WILLIAMSON COUNTY, TEXAS

CHANGE ORDER NUMBER: 1

Project: 23IFB6

Roadway: CR 404 at FM 973

SHEET
NO.

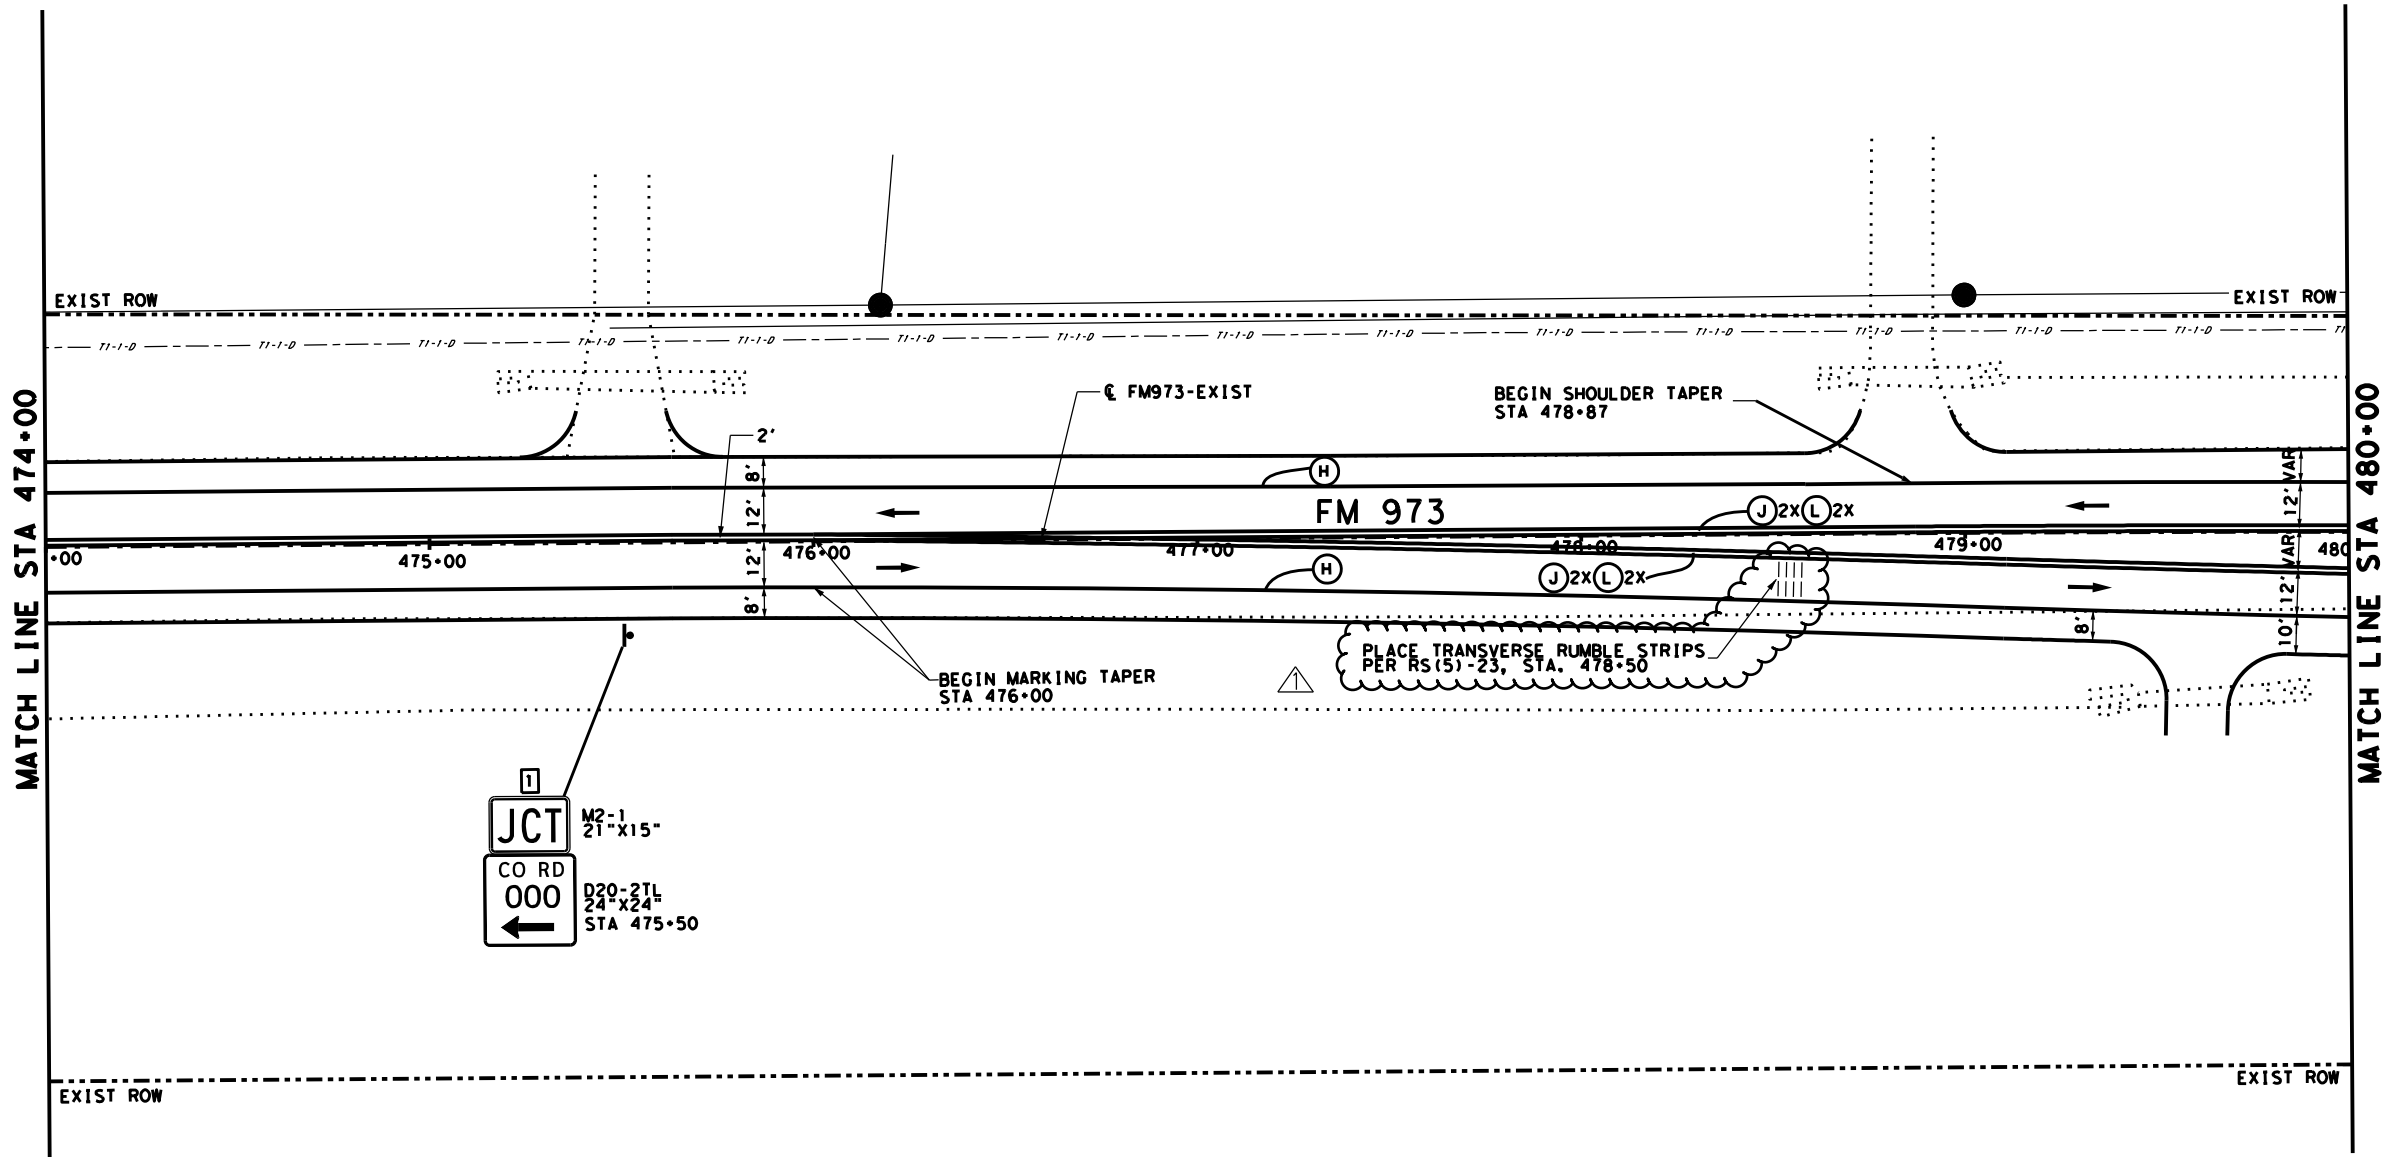
SAMSUNG DRIVEWAY REVISIONS

ADD RUMBLE STRIPS

SHEET 6 OF 16

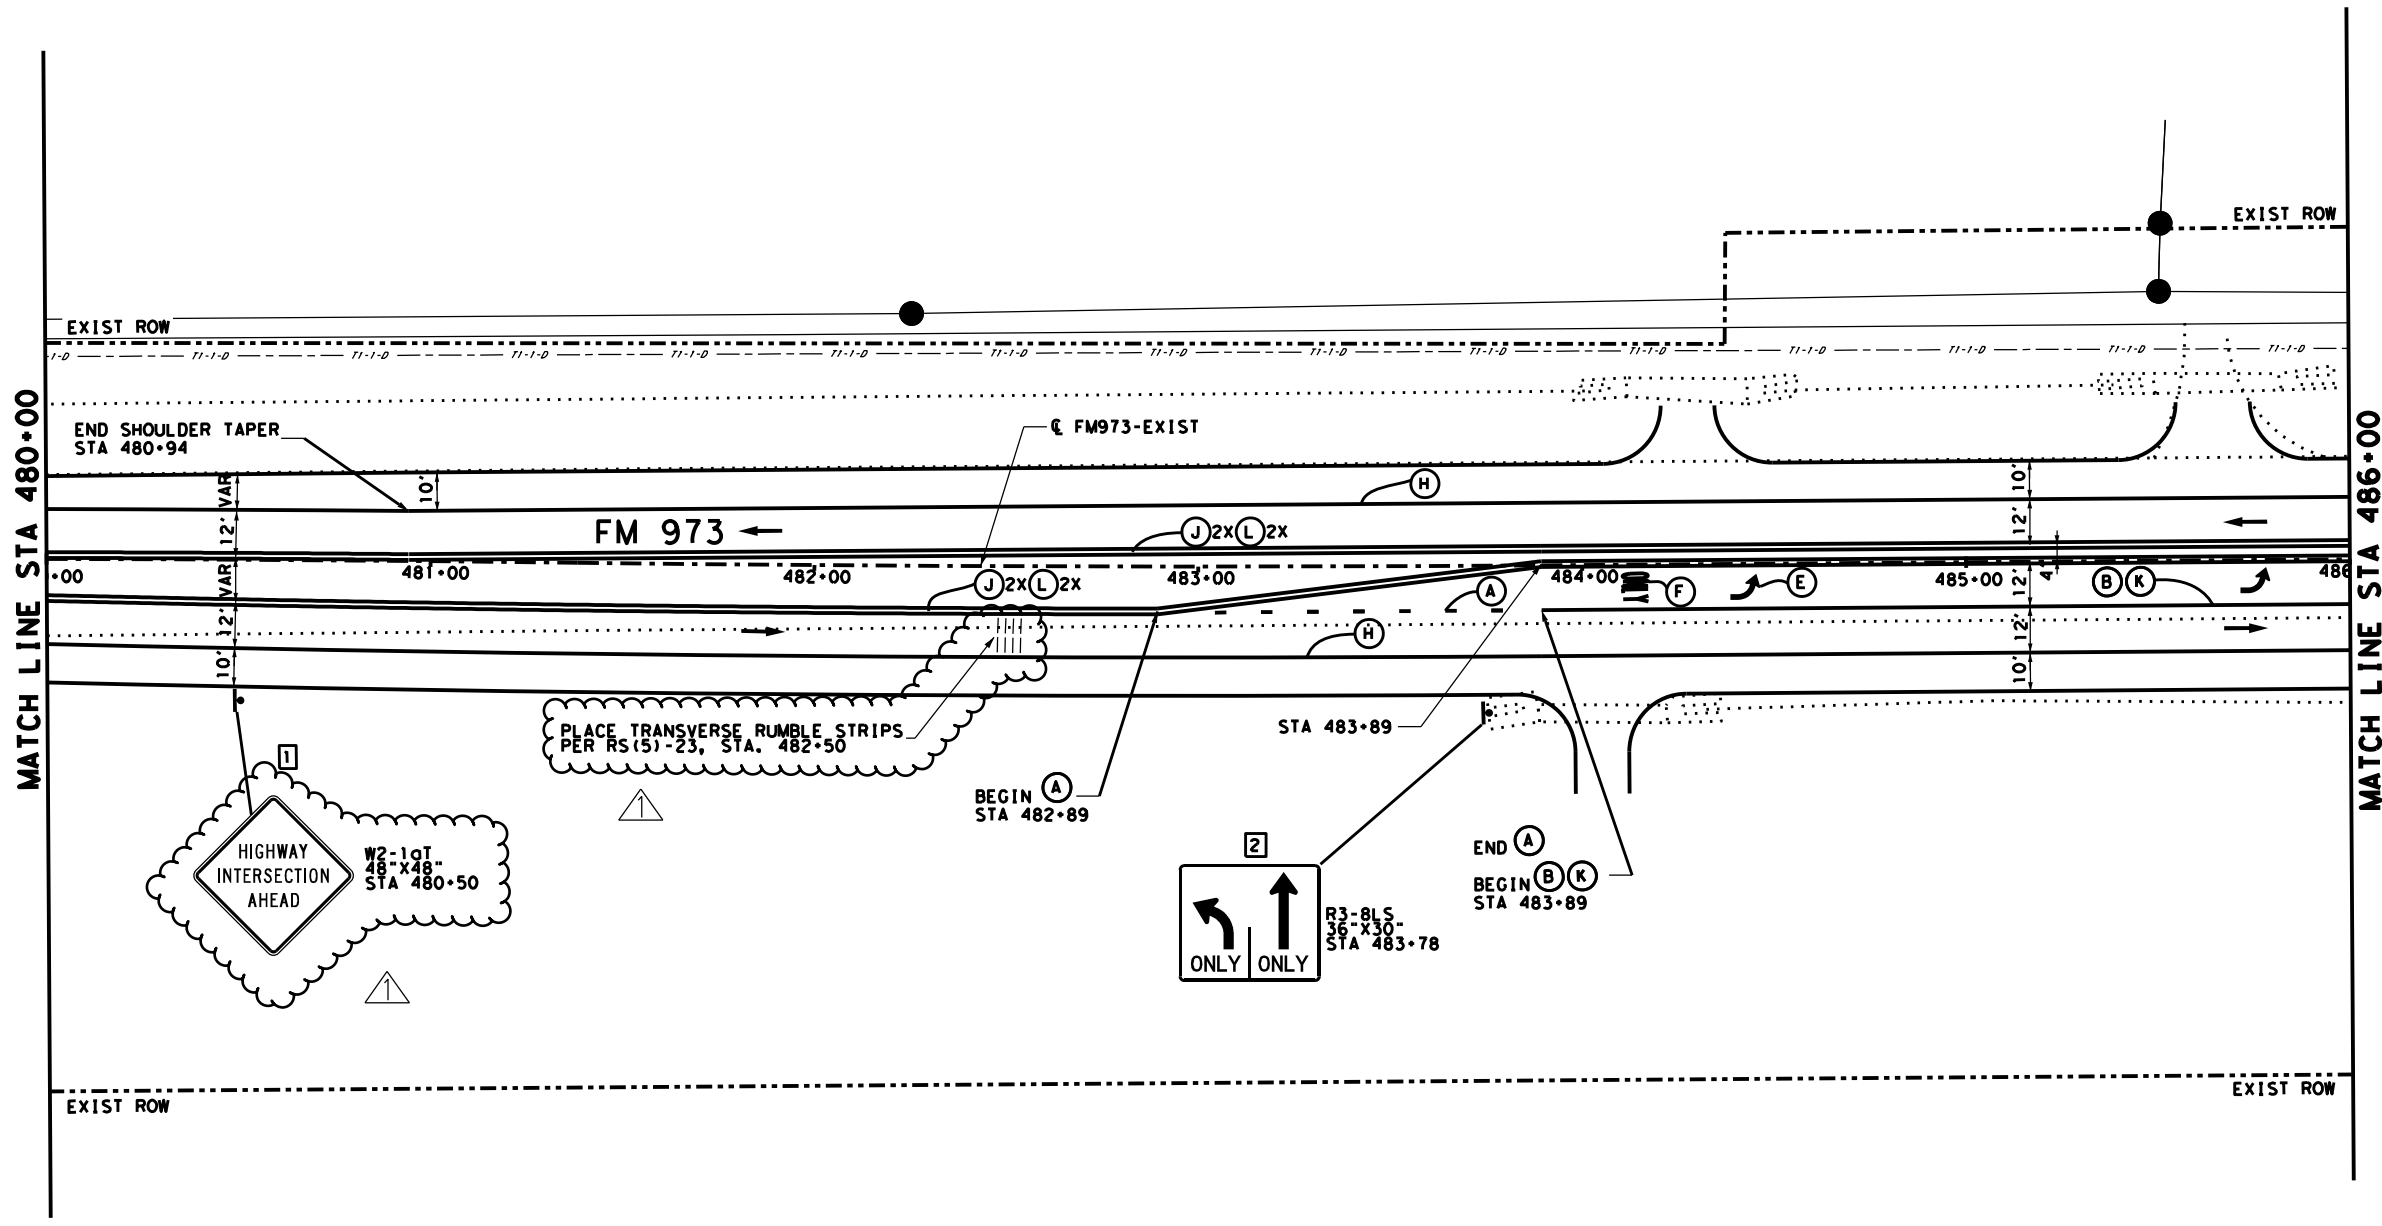
NO.	REVISIONS	BY	DATE
1	ADD RUMBLE STRIPS	RK	5/12/23

SHEET 7 OF 16

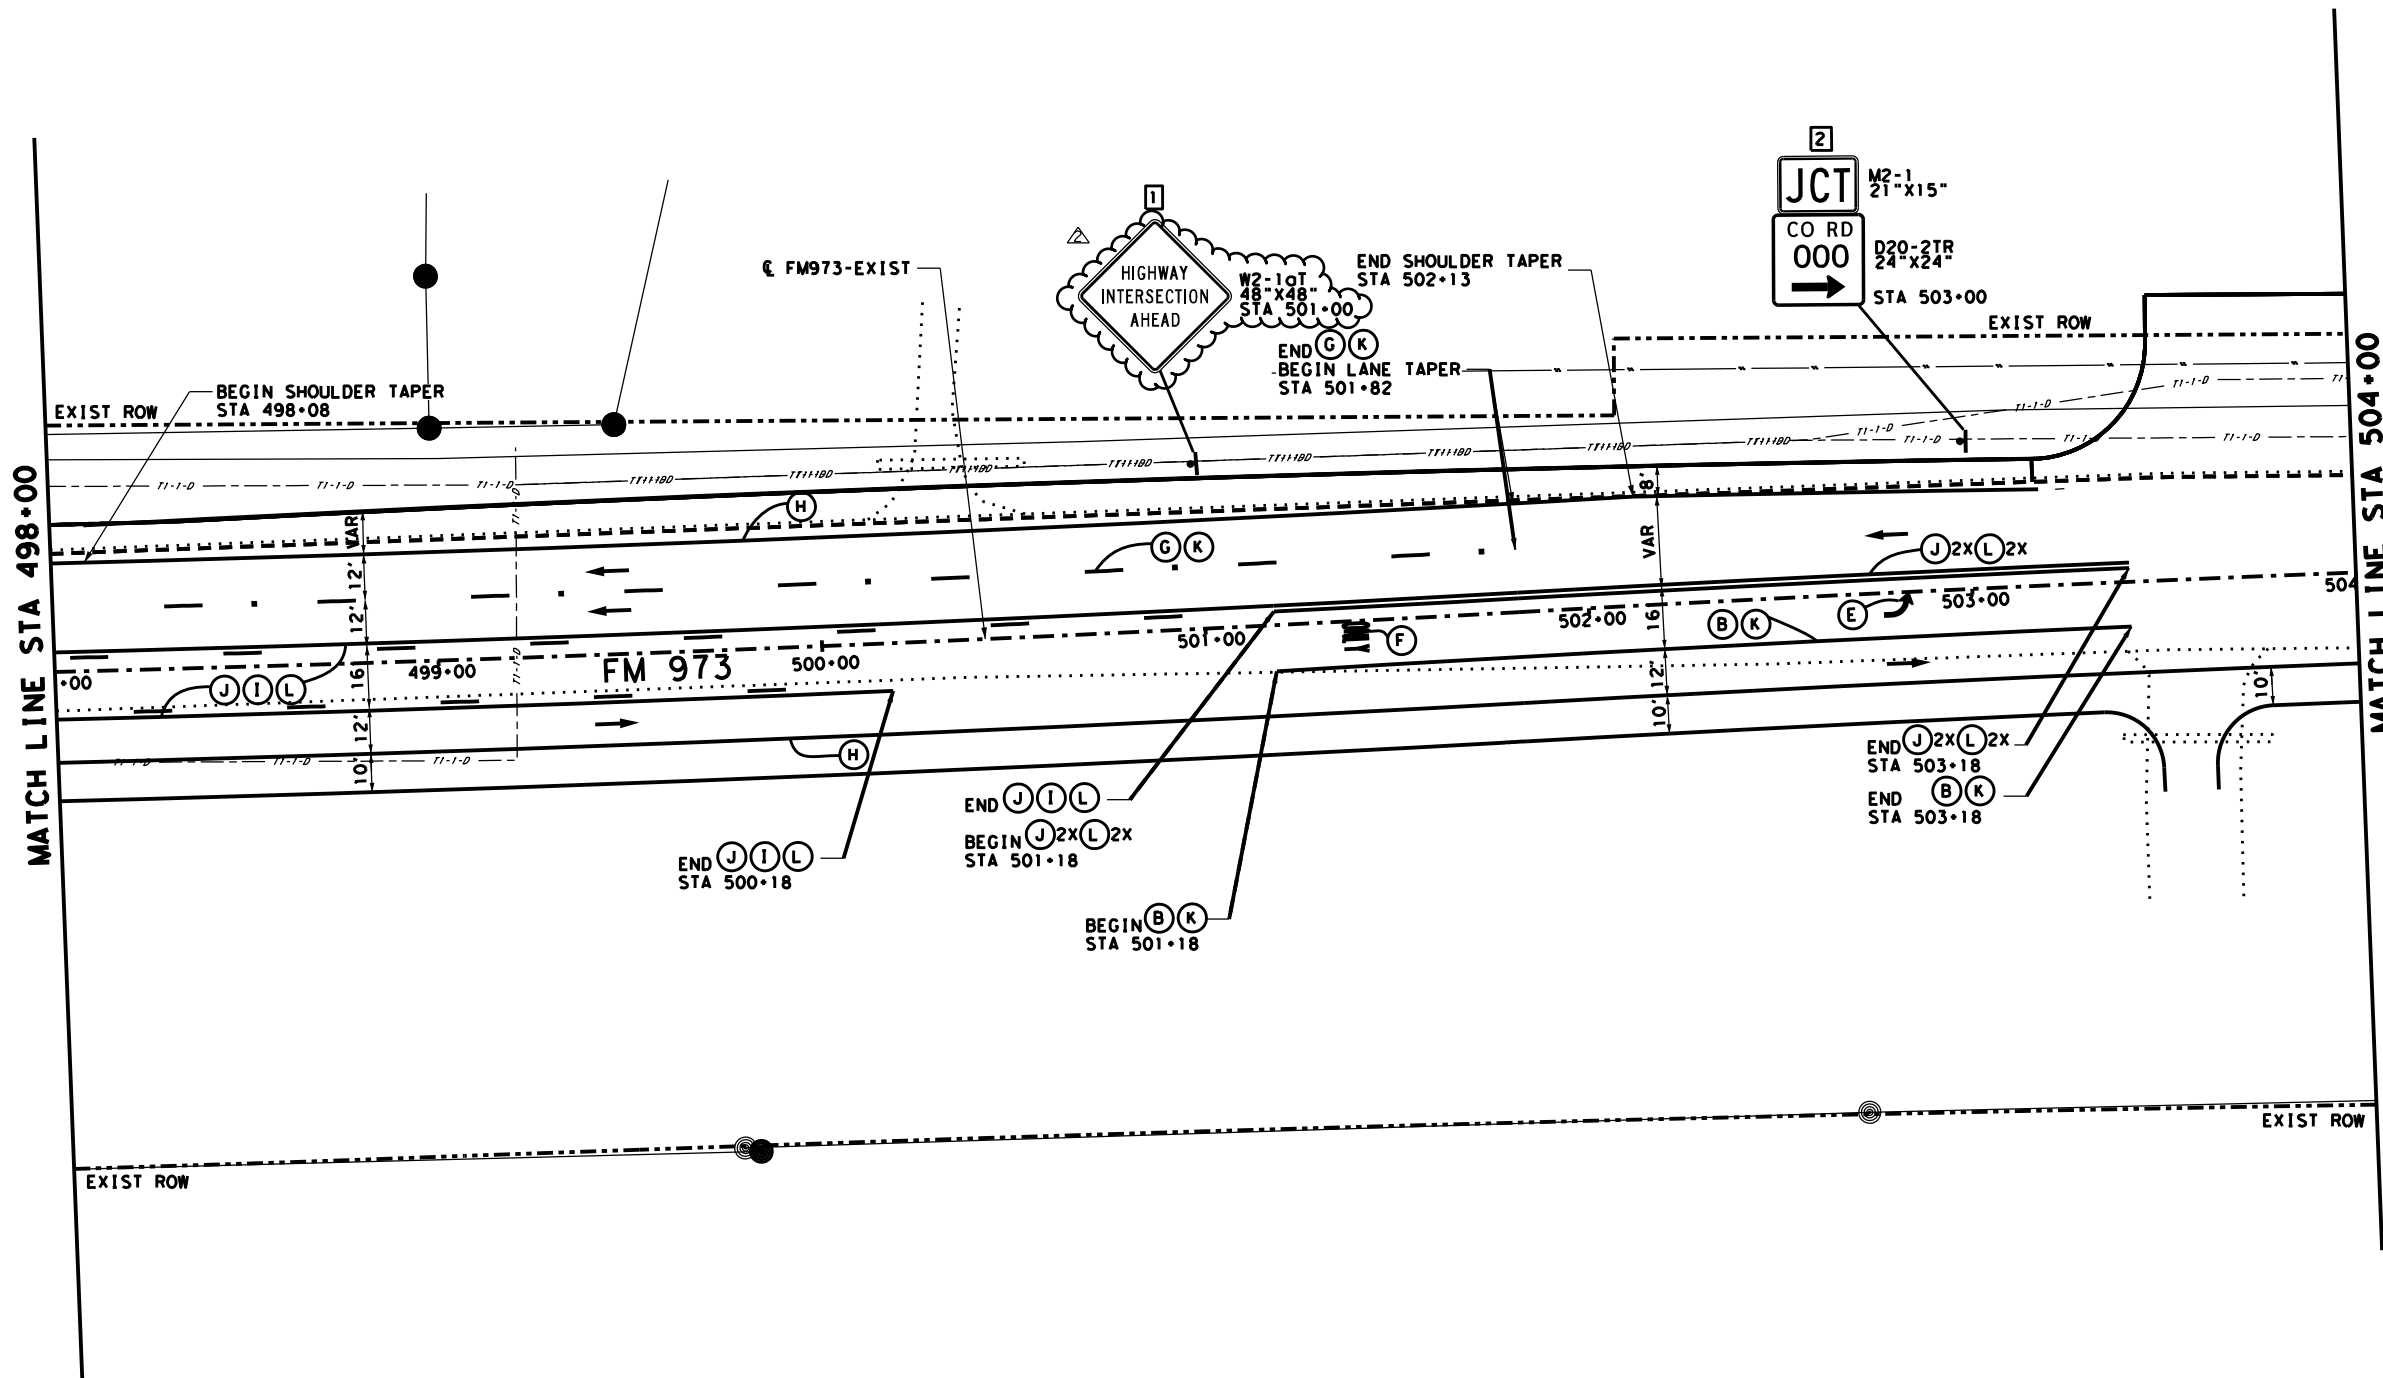
NO.	REVISIONS	BY	DATE
	ADD RUMBLE STRIPS	RK	5/12/23
